Access Compliance Report

Public Rights-of-Way

(Curb Ramps)

Intersection ID: 1002971	Main Street: CANIPE_FARM_CT	Cross Street: N/A	Location: S
ADA ID: B52F51F9E6C9	Ramp Type: Perp	Initial Pass/Fail: Fail	Overall Compliance: No
Codes/Mitigation Info/Possible Solution		Field Measurements/Component Compliance	
Severity Score: 18.75

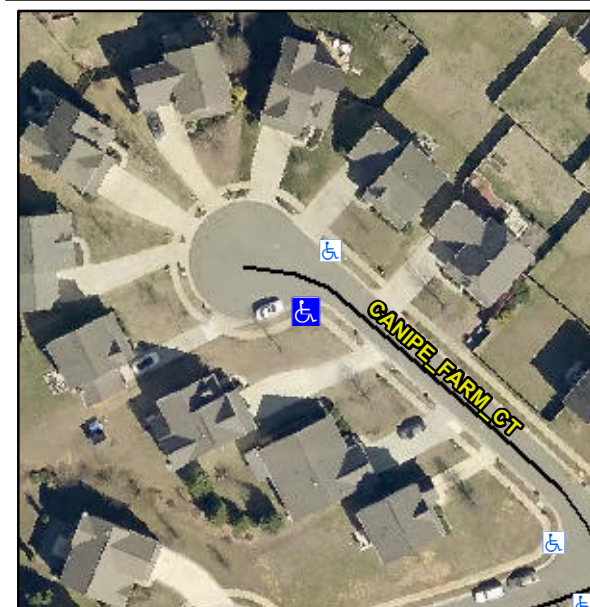
PROW/ADA:

Not Found, R304.5.1

Compliance	Description	Data	Compliance	Description	Data
N/A	Ramp Length (in)	45.0	Yes	Ramp Slope (%)	5.4
No	Ramp Width (in)	35.0	Yes	Ramp XSlope (%)	3.8
N/A	Flare Type LT	N/A	N/A	Flare Type RT	N/A
N/A	Flare Slope LT (%)	N/A	N/A	Flare Slope RT (%)	N/A
N/A	Flare Traversable LT?	N/A	N/A	Flare Traversable RT?	N/A
N/A	Landing Length (in)	N/A	N/A	DWS Provided?	N/A
N/A	Landing Width (in)	N/A	N/A	DWS Contrast?	N/A
N/A	Landing Slope (%)	N/A	N/A	DWS Length (in)	N/A
N/A	Landing X Slope (%)	N/A	N/A	DWS Full Width?	N/A
N/A	Landing Curb? (Y/N)	N/A	N/A	DWS Offset (in)	N/A
N/A	Shared Landing?	N/A			
N/A	Gutter Ponding?	N/A	N/A	Gutter Slope (%)	N/A
N/A	Gutter Lip Ht (in)	N/A	N/A	Gutter X Slope (%)	N/A
N/A	Painted X Walk1?	No	N/A	Painted X Walk2?	N/A
	X Walk 1 Direction	To N		X Walk 2 Direction	N/A
N/A	X Walk 1 Width (in)	N/A	N/A	X Walk 2 Width (in)	N/A
	X Walk 1 Slope (%)	9.0		X Walk 2 Slope (%)	N/A
	X Walk 1 X Slope (%)	4.4		X Walk 2 X Slope (%)	N/A

Possible Solutions:

Remove & Replace Entire Ramp.
